## ALADDIN SHRINE CENTER

CITY OF GROVE CITY, FRANKLIN COUNTY, OHIO  
**FINAL DEVELOPMENT PLAN**  
FOR  
**ALADDIN SHRINE CENTER**  
TITLE SHEET

RE: Aladdin Shrine Center – 1801 Gateway Circle  
Final Development Plan Resubmittal  
Application Control Number #201501050002

With this letter we are resubmitting the Final Development Plan for the Aladdin Shrine Center. We have reviewed the comments provided in your letter dated January 16, 2015, and offer the following responses for your consideration:

Drawing Number:  
**1 / 6**

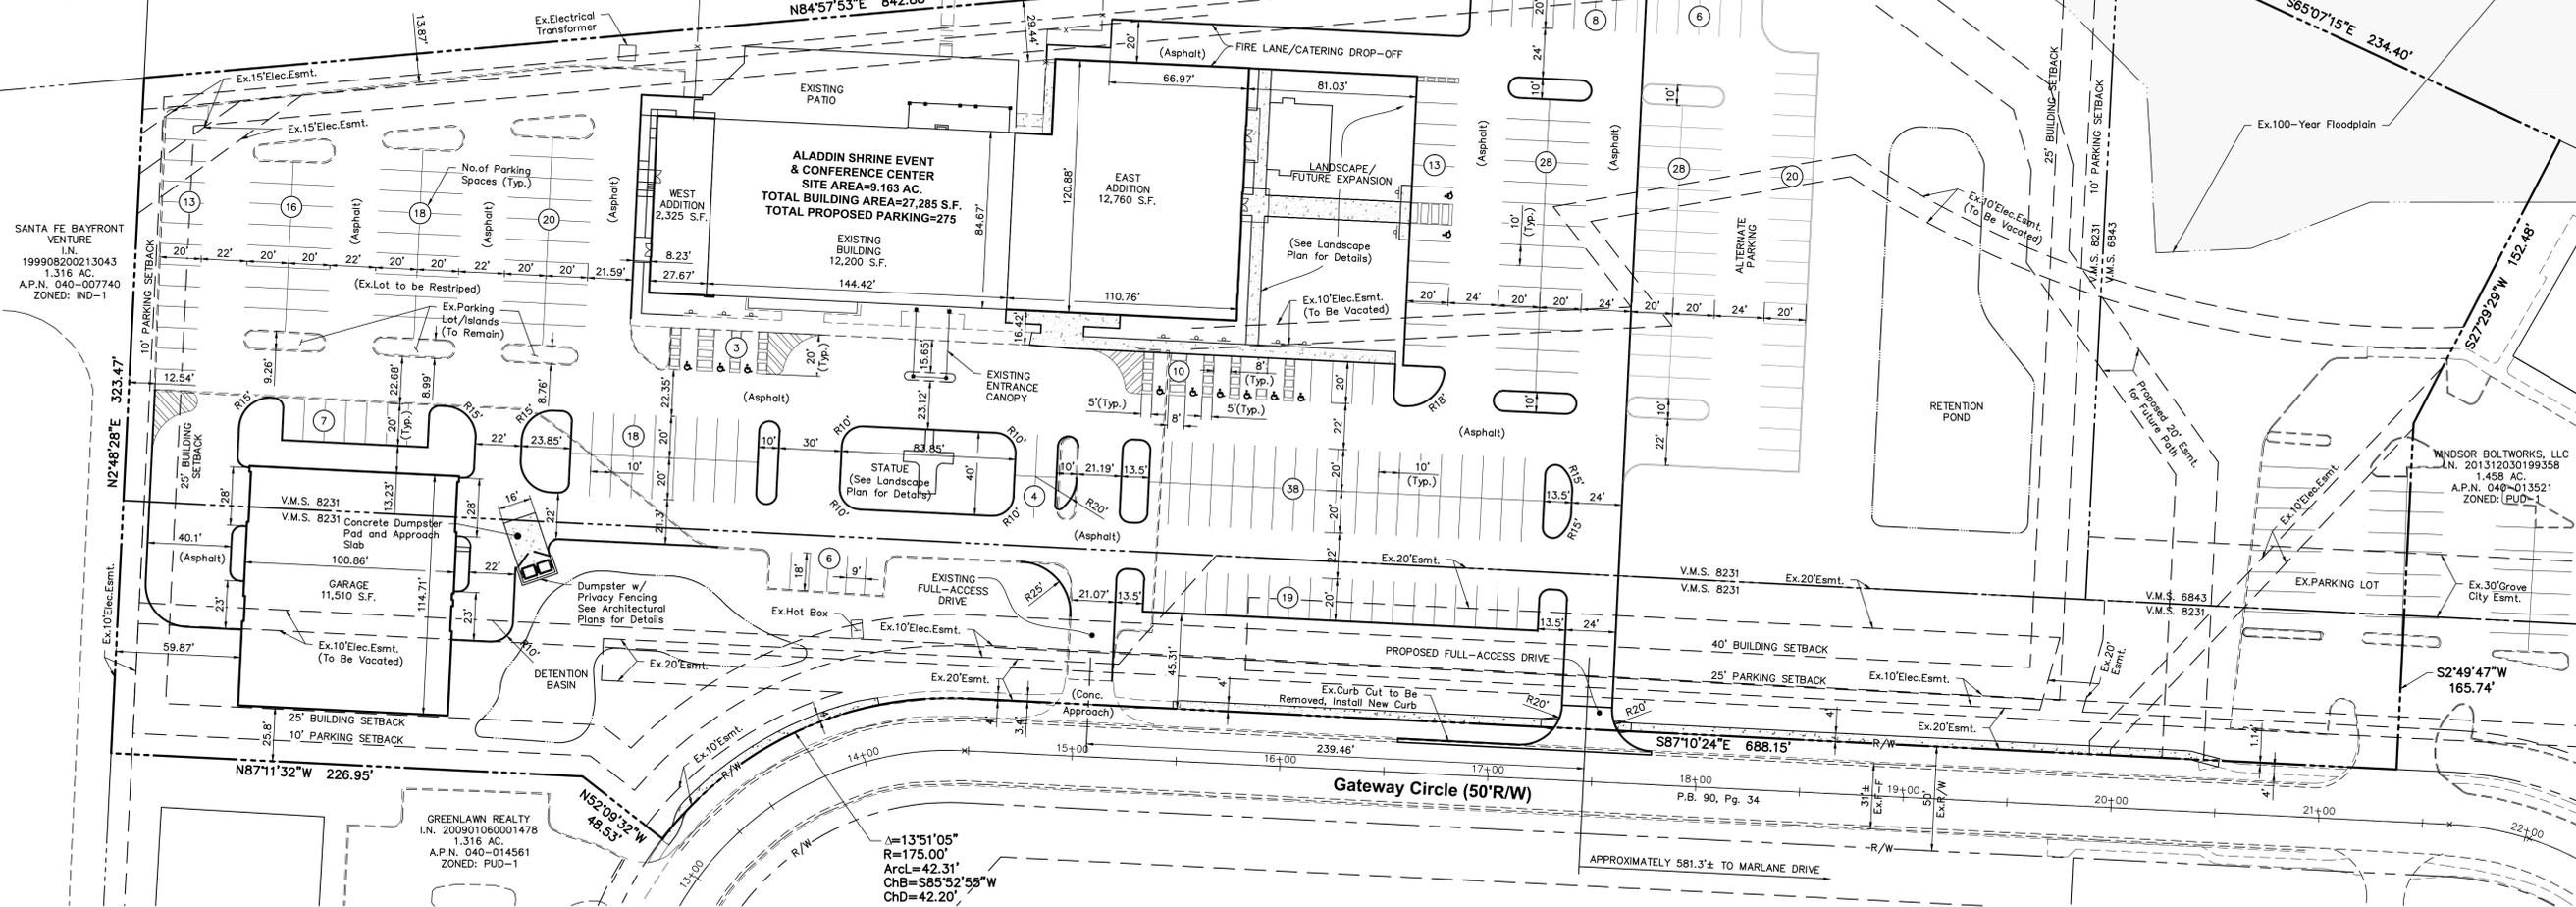
1. The development standards should be removed from sheet 1/6 and replaced with the zoning restrictions approved with C-66-98.

No.	Revision	Date	Approved
<b>PRELIMINARY NOT FOR CONSTRUCTION</b>			
Date: 01/28/2015			
Scale: 1" = 40'			
Drawn By:	JRS	Checked By:	DDD
Project Number: 14-0001-669			
Drawing Number: 2/6

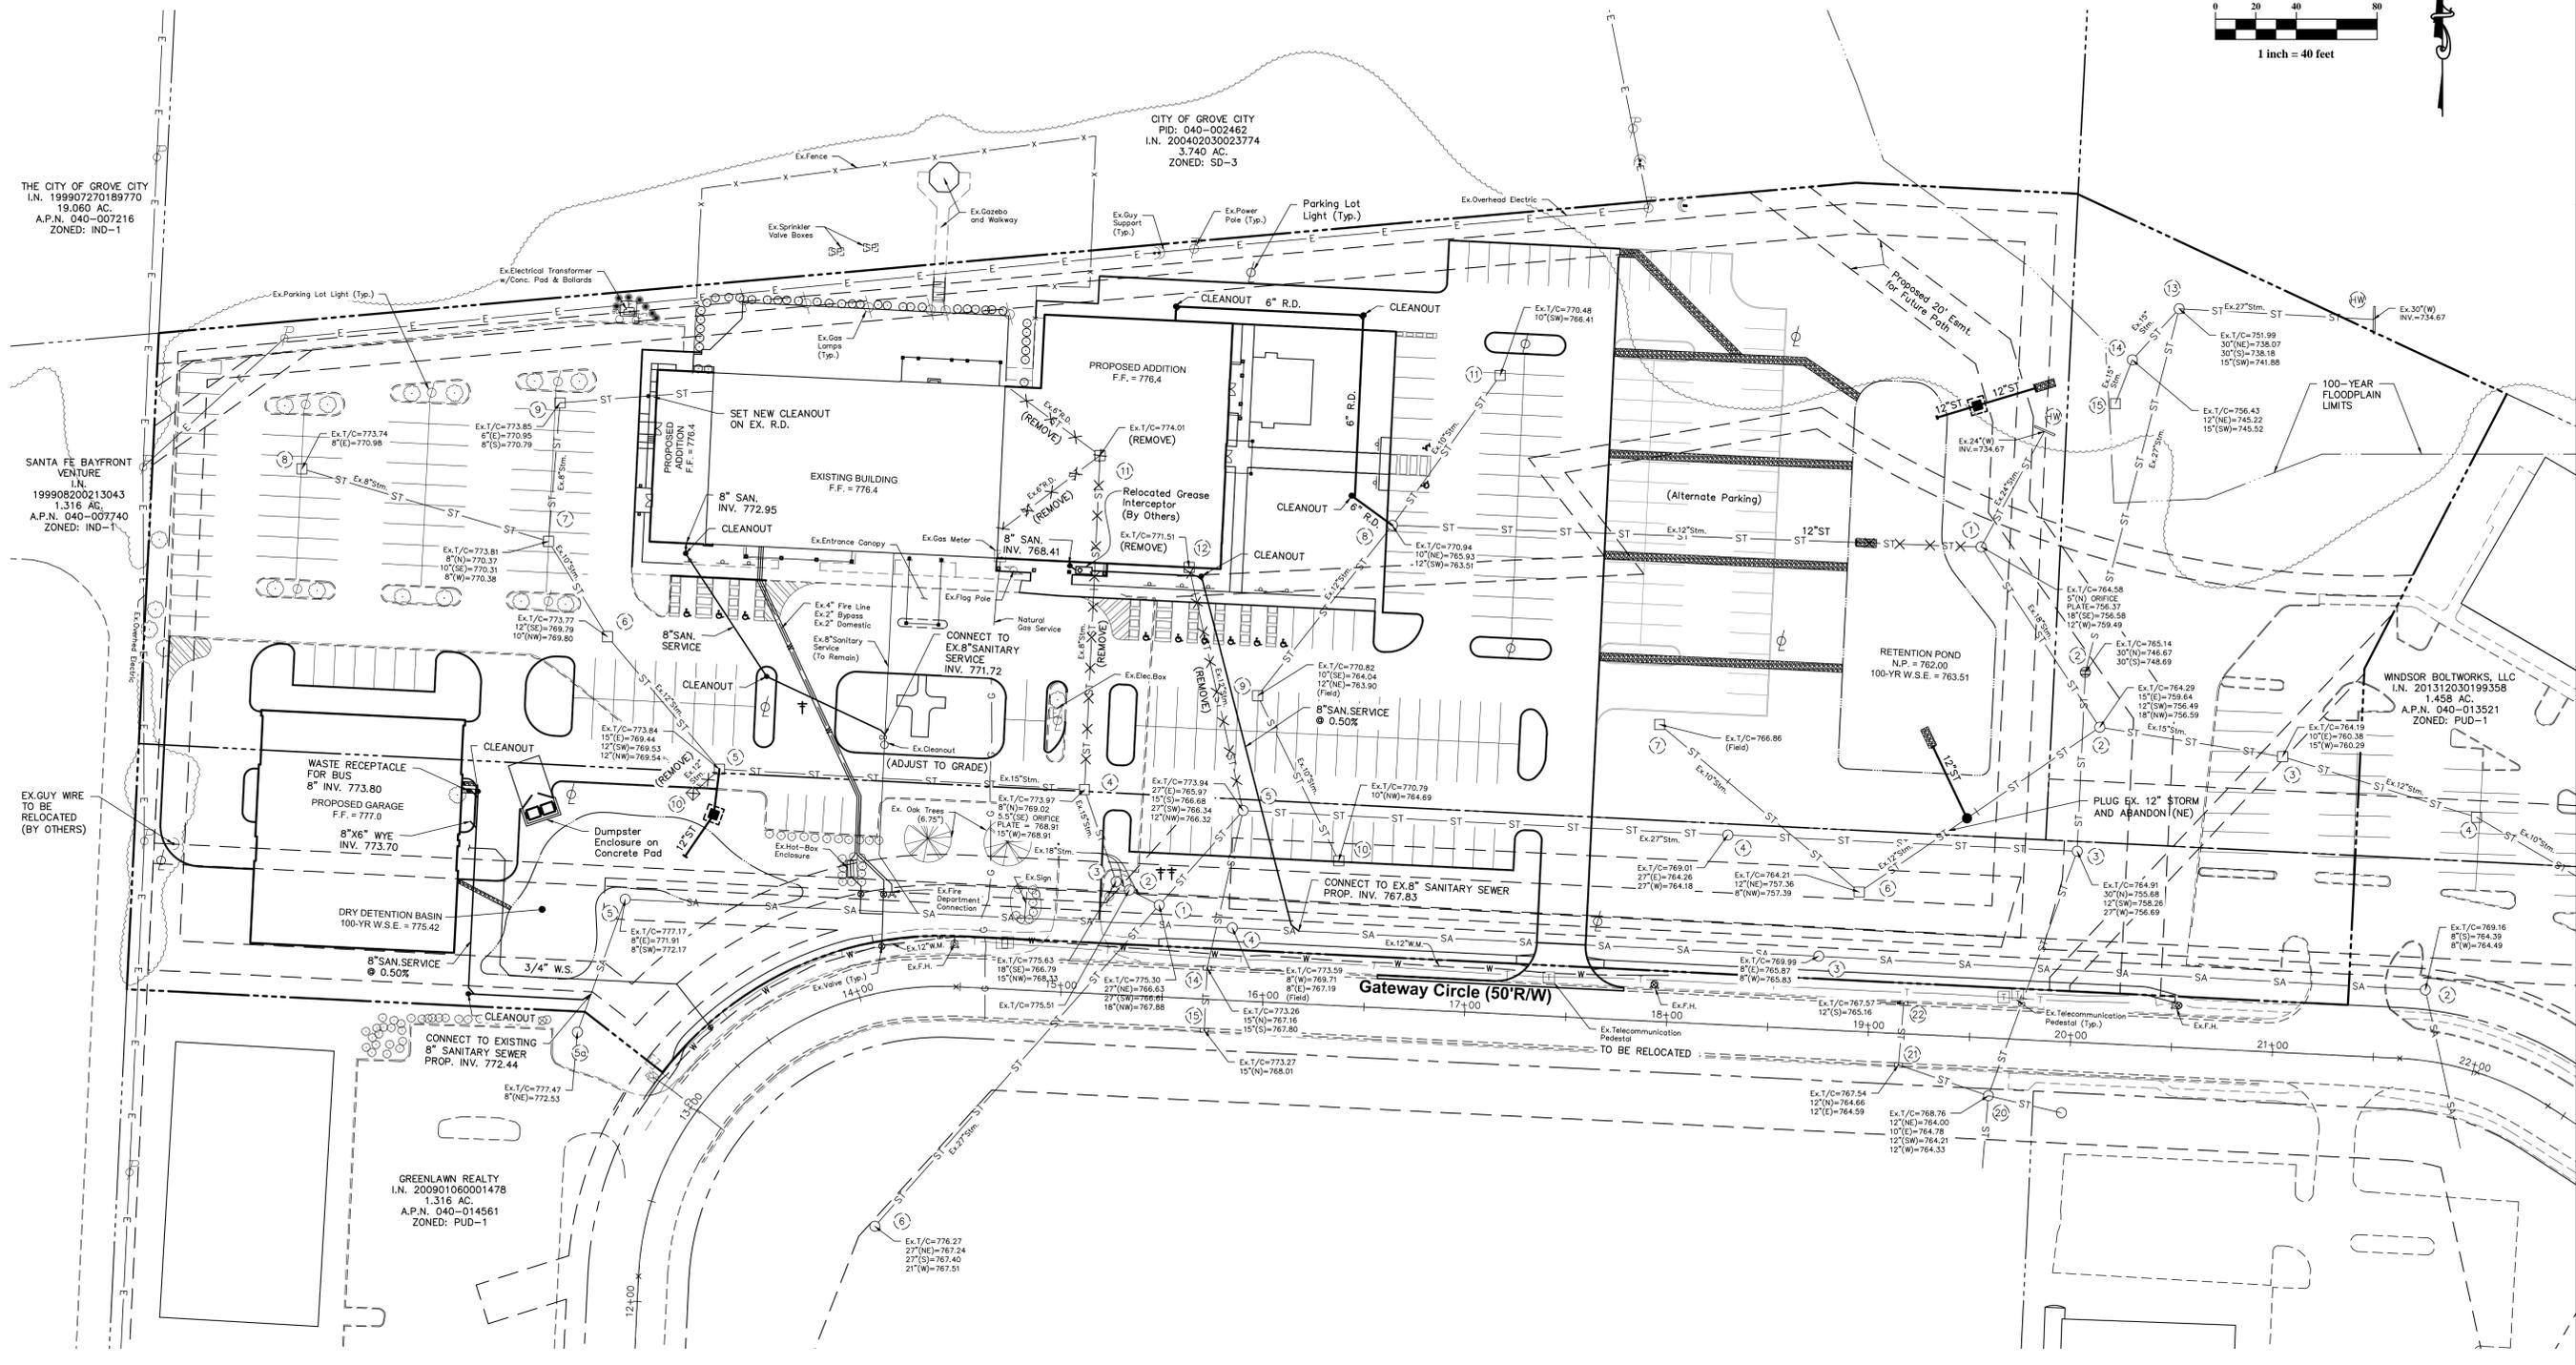
5. A note should be added to item number 15 on sheet 2/6 that all rooftop mechanicals will be screened by raised parapet.

8. On sheet AS1.0, plans show a striped parking peninsula northwest of the garage facility. This is contradictor to sheet 2/6 which shows it curbed. Per chapter 1136 all parking lot peninsulas and islands are to be landscaped.

20. The Site Dimension Plan (2/6) shows existing public sidewalk across the frontage of all three parcels. Currently, sidewalk only exists in front of the site that was previously developed for Grand Oaks Event and Business Center (middle parcel of the three). Additionally, the Grand Oaks plans (dated 1/26/10) shows that the public sidewalk for that project was to be located inside the public right of way, while this Development Plan shows it to be located behind the right of way. Please verify the location of the existing sidewalk with respect to the right-of-way and update the Site Dimension Plan accordingly. Additionally, please use different line weights and callouts to indicate which section of public sidewalk is existing and which is proposed by this development.

**-Note added**

**- This area was intended to be a striped island and has been corrected on sheet 2/6 of the Final Development Plan**

**A ARCHITECTURAL SITE PLAN - NEW WORK**

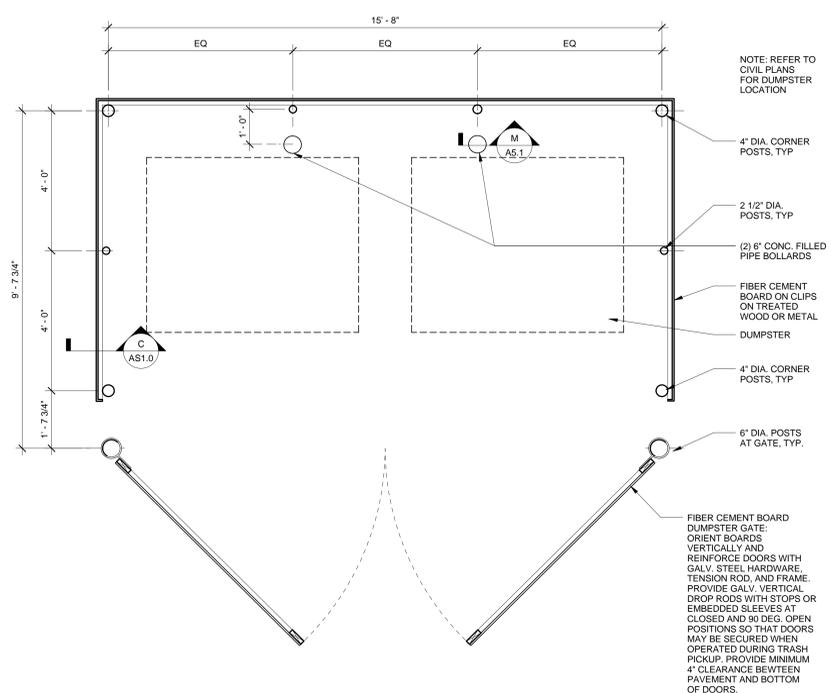
6. Phasing for the proposed project should be discussed in the project narrative. Future parking is shown east of the primary parking lot but no indication on when this parking lot is to be installed is given. Additionally, on sheet AS1.0 this area is referred to as “Alternate Parking” please clarify the intent of this area, if it is to be future parking the annotation should be changed to reflect that on sheet 2/6.

**- The parking area should be labeled on all plans as “Alternate Parking”. The intent is to obtain a separate price during bidding for this “Alternate” area to determine if the project budget will allow for the additional cost at this time. If not, the construction of those parking spaces will be postponed to an indeterminate time. This information has been added as a note on the plan.**

**D DUMPSTER ENCLOSURE ELEVATION**

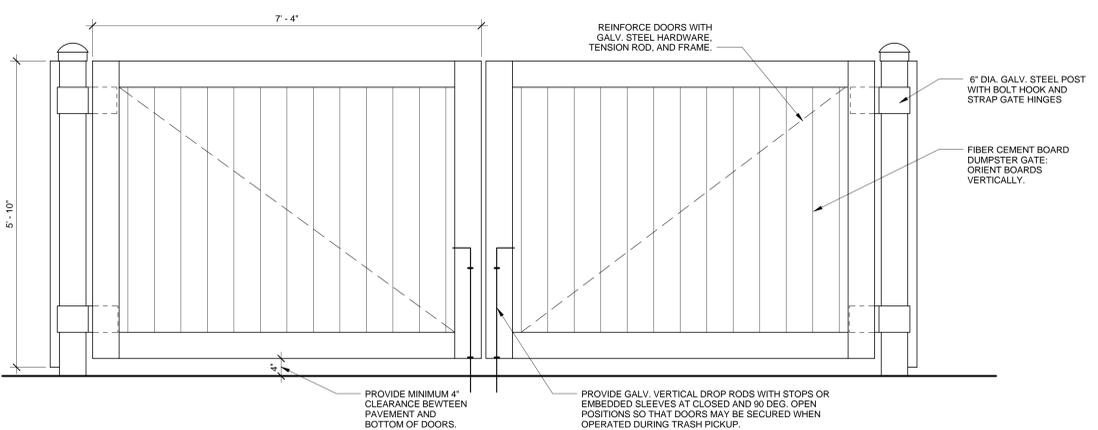
10. The dumpster should be finished with the same level of detail/treatment as the primary structure, with a combination finish of masonry finish and EIFS materials.

**- Per conversation with Kyle Rauch with Grove City, he is willing to support the enclosure being constructed of hardy plank due to budgetary and maintenance concerns. This is acceptable only if it is screened by the placement of additional landscaping. Landscaping shall be provided in an appropriate species and quantities with appropriate installation heights to provide a minimum opacity of 80% or greater. See the attached updated landscape plans showing compliance.**
